Drawn by:	ACI Standard Erection Manual		
WK	Chapter:17	Section: 17.3	Drawing: SWP3
Approved:	SWP Sections		
DJ	Submitted: 8/10/09	Revised:

Drawn by:	ACI Standard Erection Manual		
WK	Chapter:17	Section: 17.4	Drawing: SWP4
Approved:	SWP Sections		
DJ	Submitted: 8/10/09

SWP1 Starting Soffit Layout

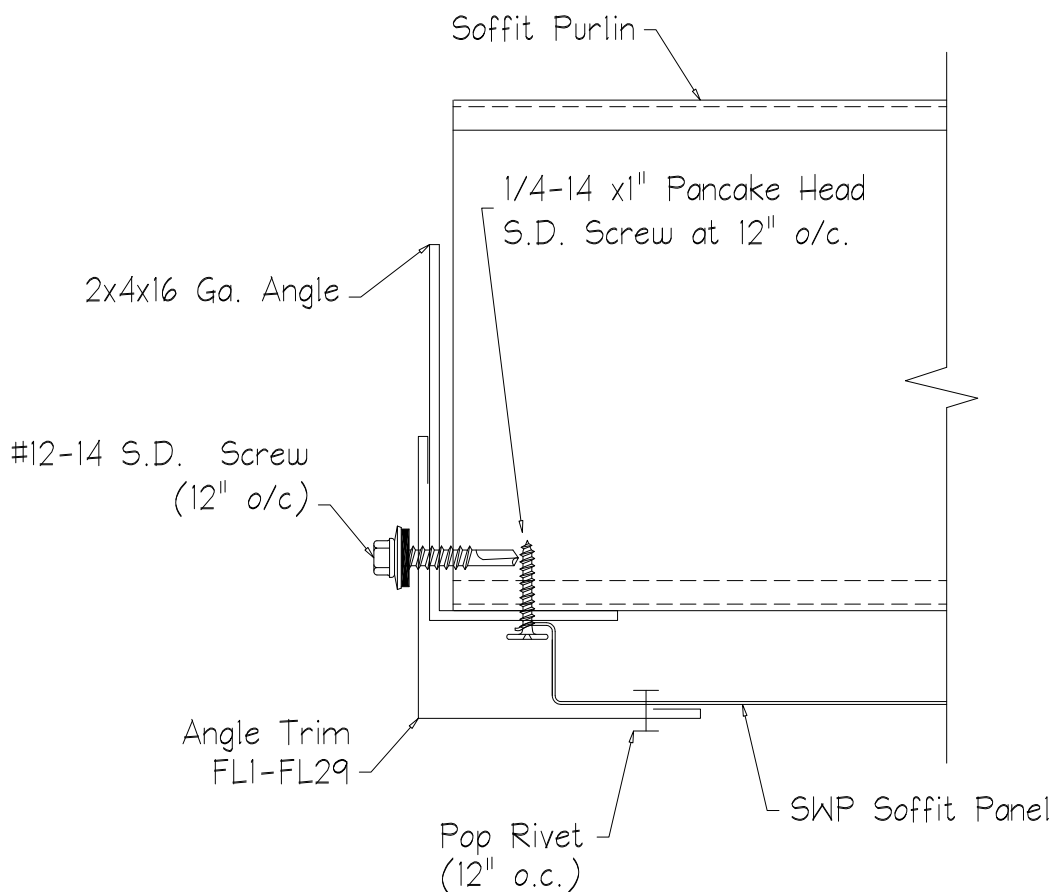
Revision	Date	Description
1	6/14/2010	#10 changed to 1/4-14X1" screws, angle trim corrected
2	8/2/2010	Added pop rivets

Ending Soffit Panel Layout (w/o Wall Panel)

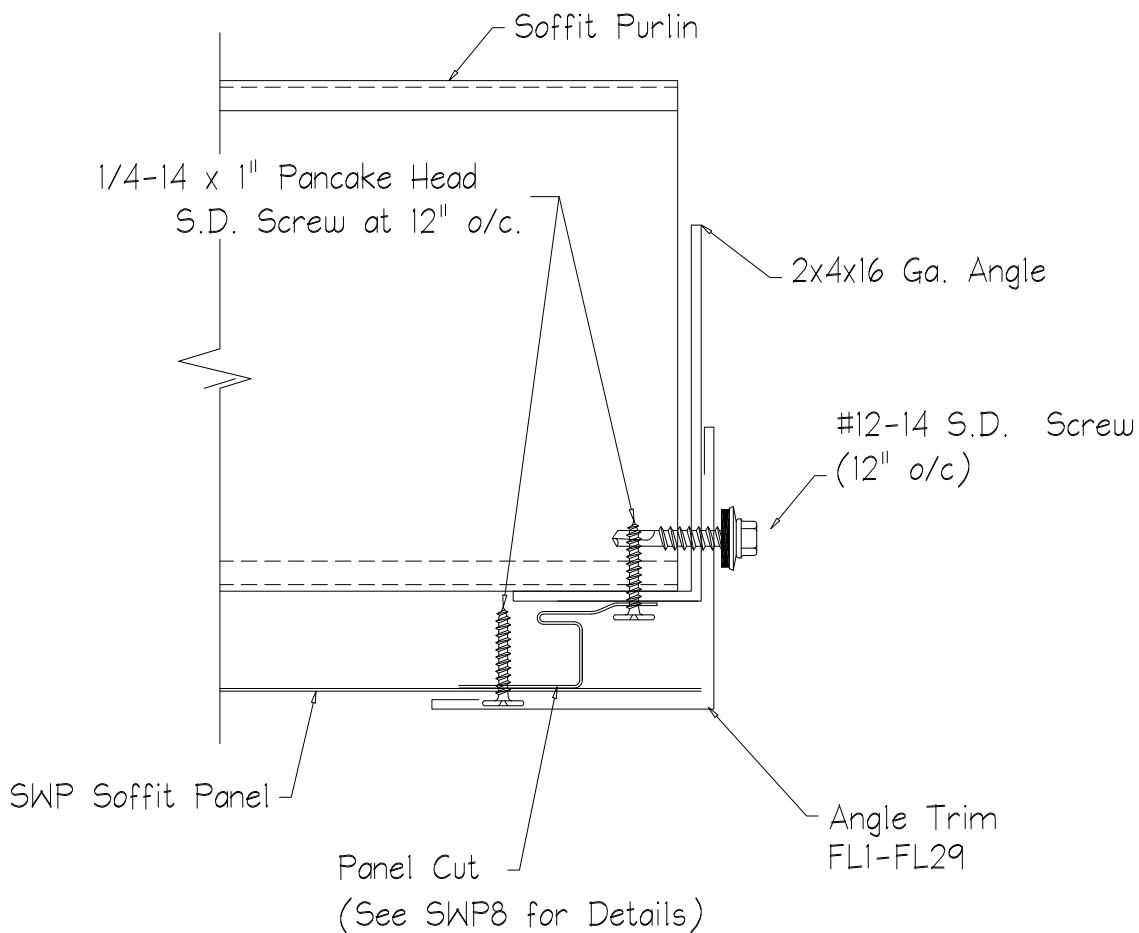
Revision	Date	Description
1	6/14/2010	#10 changed to 1/4-14X1" screws, angle trim corrected
1	8/2/2010	Panel Drop changed to panel cut and note added

Installation of Stitch Screw

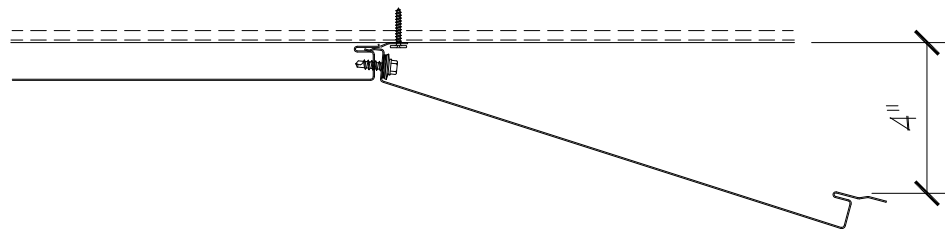
Revision	Date	Description
1	6/14/2010	#10 changed to 1/4-14X1" screws

SWP4 Section at Jamb Trim

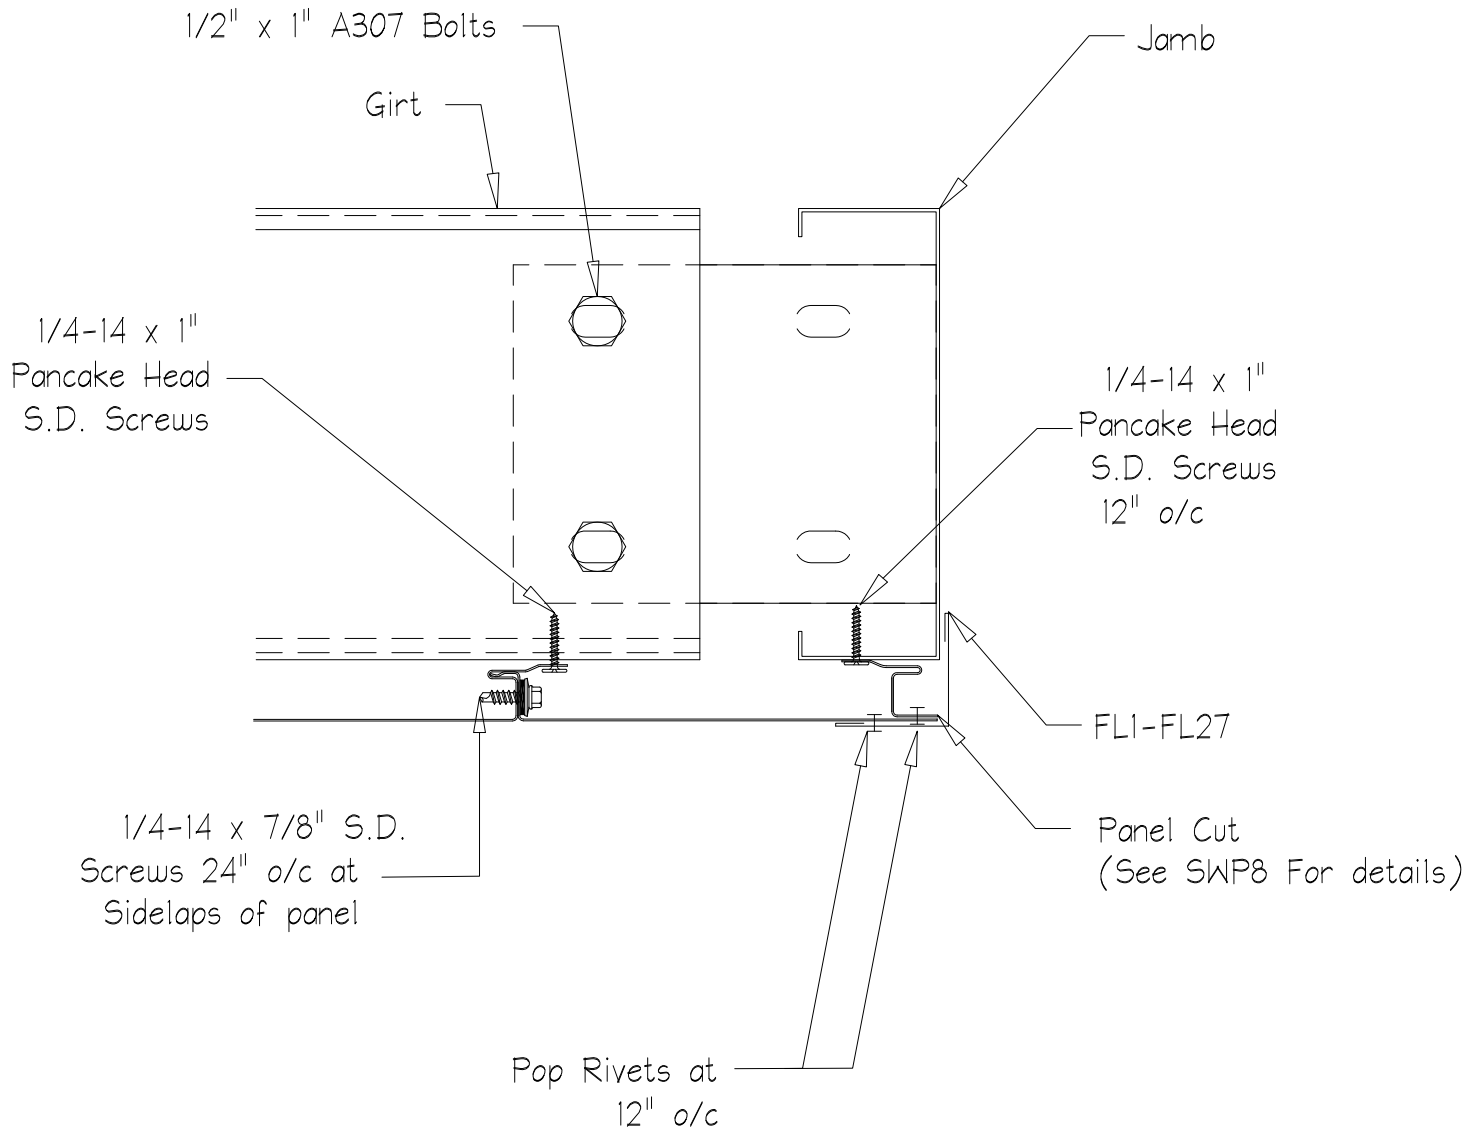
Revision	Date	Description
1	6/14/2010	#10 changed to 1/4-14X1" screws
2	8/2/2010	Panel Drop changed to panel cut and note added

Section at Head Trim

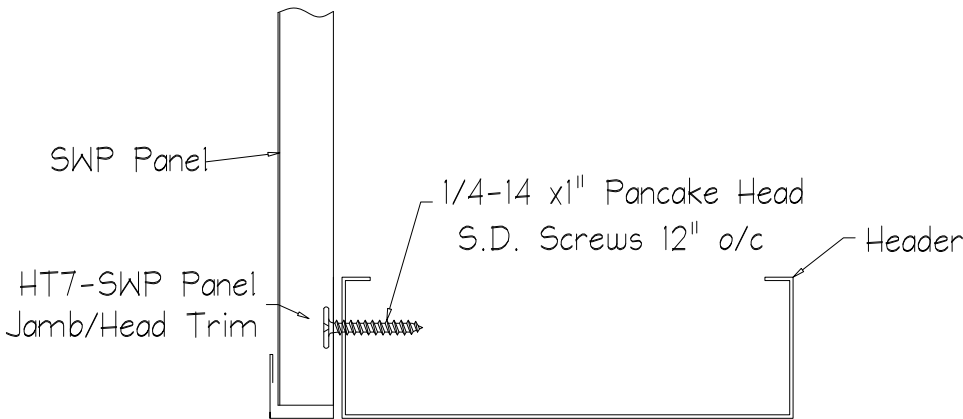
Revision	Date	Description
1	6/14/2010	#12 changed to 1/4-14X1" screws

SWP6 Section at Soffit Peak trim

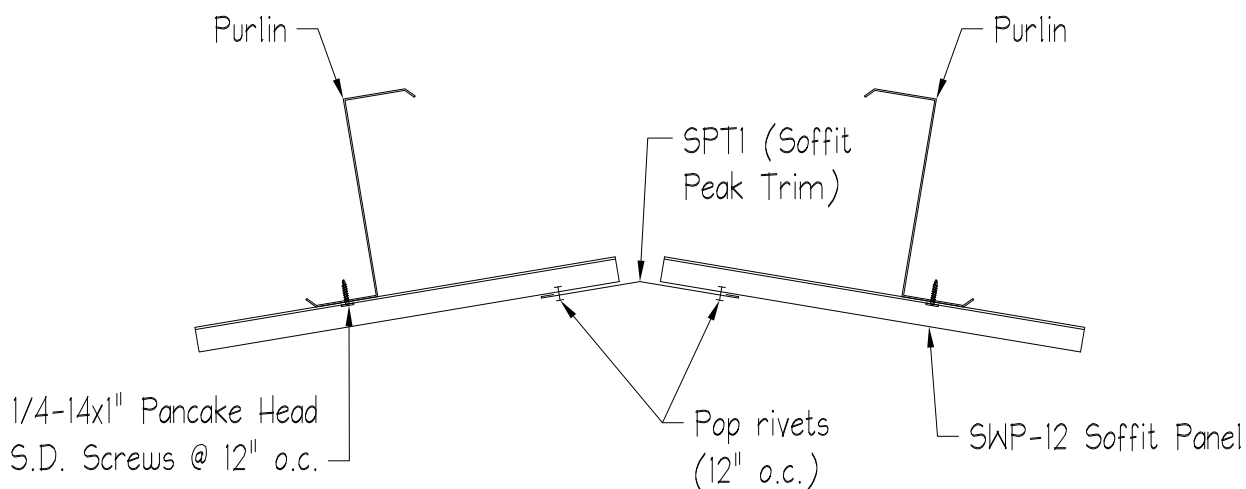
Revision	Date	Description
2	8/2/2010	Changed pop rivet spacing
